UNITED STATES  
DEPARTMENT OF THE INTERIOR  
BUREAU OF LAND MANAGEMENTFORM APPROVED  
OMB NO. 1004-0135  
Expires: July 31, 2010**SUNDRY NOTICES AND REPORTS ON WELLS**  
**Do not use this form for proposals to drill or to re-enter an abandoned well. Use form 3160-3 (APD) for such proposals.**5. Lease Serial No.  
NMNM53218

☒ Oil Well ☐ Gas Well ☐ Other2. Name of Operator  
OXY USA WTP LPContact: DAVID STEWART  
E-Mail: david\_stewart@oxy.com8. Well Name and No.  
RIGHTHAND CANYON 34 FEDERAL 19. API Well No.  
30-015-270463a. Address  
P.O. BOX 50250  
MIDLAND, TX 797103b. Phone No. (include area code)  
Ph: 432-685-5717  
Fx: 432-685-574210. Field and Pool, or Exploratory  
INDIAN BASIN UP. PENN

**OXY USA WTP LP - Proposed  
Righthand Canyon 34 Federal #1  
API No. 30-015-27046**

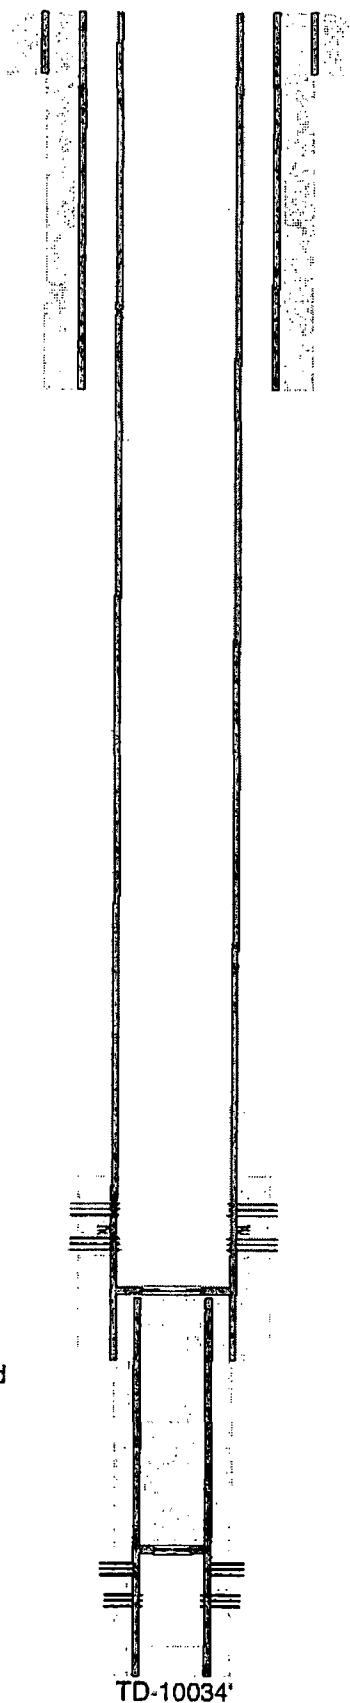
*Add plug: Perf 2700, sqz cmt to 2570  
(Top Glorietta), WOC Tag.*
